# Comments on applications for referral under the COVID-19 Recovery (Fast-track Consenting) Act 2020

| <b>Project name</b>                              | Jervois Quay Project  |

***Request for Further Information Pursuant to Section 92(1) of the Resource Management Act 1991***

| Site Address:         | 110 Jervois Quay (MFC carpark)   |

Excerpt from Plan RC\_002 showing the site plan which shows the underground wastewater tank and the existing public stormwater culvert

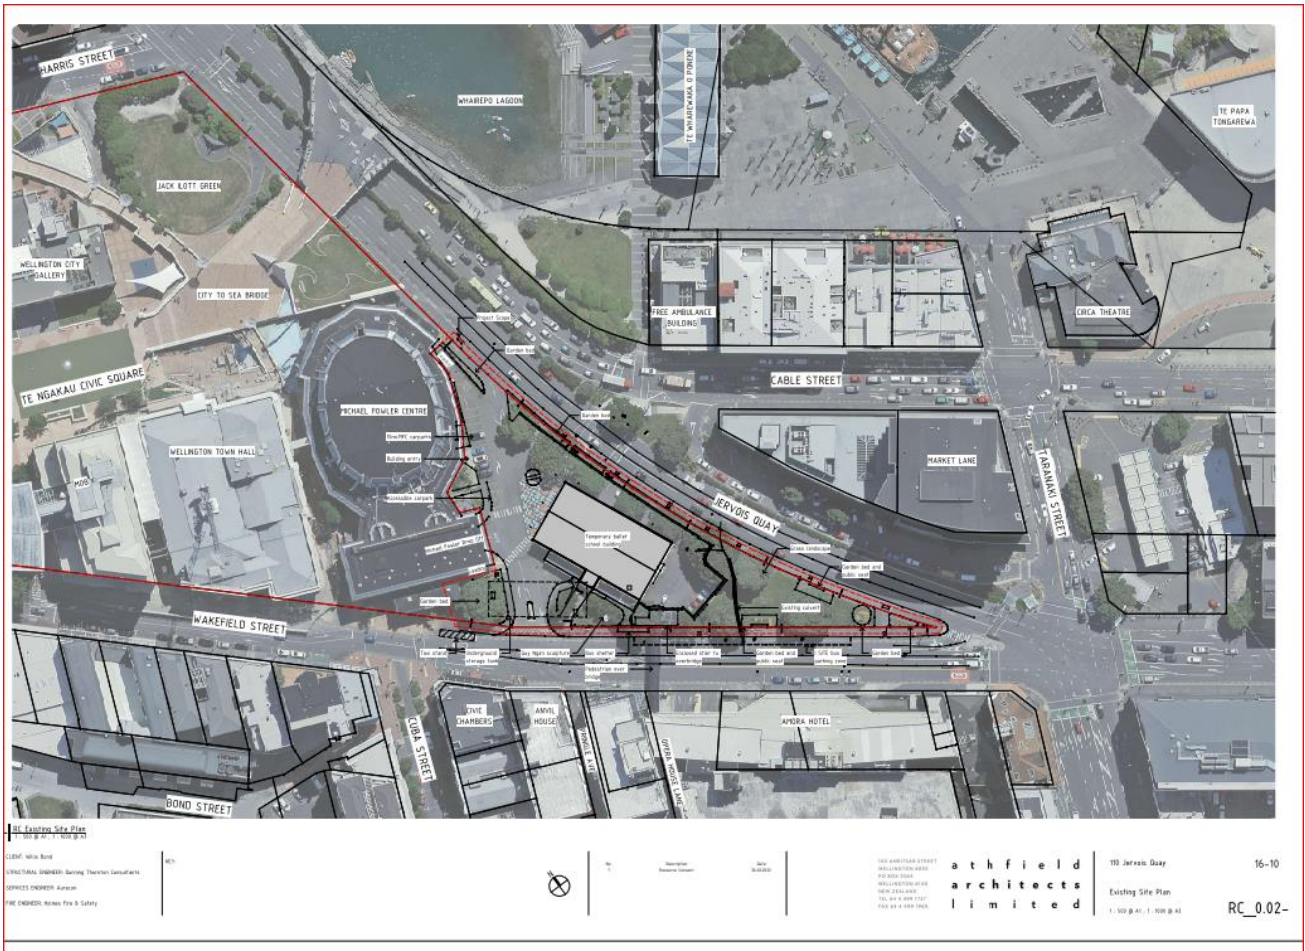
| <b>General comment</b> | <p>Wellington Water Limited makes this submission in its capacity as the existing network management and maintenance service provider to the Wellington City Council.</p> <p>Wellington Water has outstanding concerns regarding Jervois Quay Project’s potential impact on two significant water assets that are on the development site, specifically:</p> <ul style="list-style-type: none"> <li>- The Michael Fowler Centre (MFC) wastewater storage facility is a concrete storage tank with a capacity of around 850m<sup>3</sup>. The facility provides wastewater overflow storage and is a key network asset to manage potential wastewater discharges to the Wellington Harbour; and</li> <li>- A stormwater main that is ~100-year old ovoid brick pipe (1220mm by 2210mm) and serves a large stormwater catchment originating from the Aro Valley.</li> </ul> <p>The proposed building over these two assets will have implications for their ongoing and future operational management and replacement, and result in increased risk to the assets during construction.</p> <p>Wellington Water has reviewed of the proposed plans RC2.00- 2.03; 1.01; 0.02 dated 26 Feb 2022, and Landscape Plans L1.01 – L1.02. The proposed plans do not alleviate WWL’s concerns regarding the potential impact to the level of service the wastewater tank is designed to provide in this location in the city, and the challenges of suitable alternative land availability if a tank were to be replaced. Further, the proposed building on the site will result in restricted access to this facility for both maintenance and its future replacement. Wellington Water is also concerned with the operational impacts from this storage facility such as odour when in use or maintenance on the future residents of the proposed development/building</p> <p>This stormwater main is theoretically at the end of its useful life and its condition cannot be confidently determined from available techniques such as closed circuit television survey (CCTV). This is because the pipe is located in a potential fill area and therefore may not be fully supported insitu on competent ground/materials. The pipe is also likely to be vulnerable to movement and cracking in large earthquakes and any failure has the potential for liquefied materials to enter the</p> |

|  | <p>pipe during earthquakes resulting in partial loss of service. If this stormwater pipe fails the repairs may become very difficult and costly.</p> <p>Wellington Water’s considers that effects to the stormwater pipe are able to be mitigated through either structurally lined or it is replaced along a new alignment outside the perimeter of the proposed building. Either option would result in a more resilient pipeline, reduce its failure risk and increase the asset life by around 50 years. These options are in accordance with the RSWS <i>Section 4.12 Building in close proximity to pipes</i>.</p> <p>In addition to the above matters, Wellington Water has wider interest in the proceedings to ensure that effects to the operational three water networks are appropriately avoided or mitigated, and that consent conditions for design, construction, and connection of new 3-W assets are included where relevant.</p> |
| <p><b>Other considerations</b></p>                   | <ol style="list-style-type: none"> <li>1. Wellington City Council has requested Wellington Water (7 April 2022) to undertake an assessment regarding the replacement of the wastewater tank – this has not been completed.</li> <li>2. The applicant is undertaking a DSA of the wastewater tank – this has not yet been completed.</li> </ol>  |
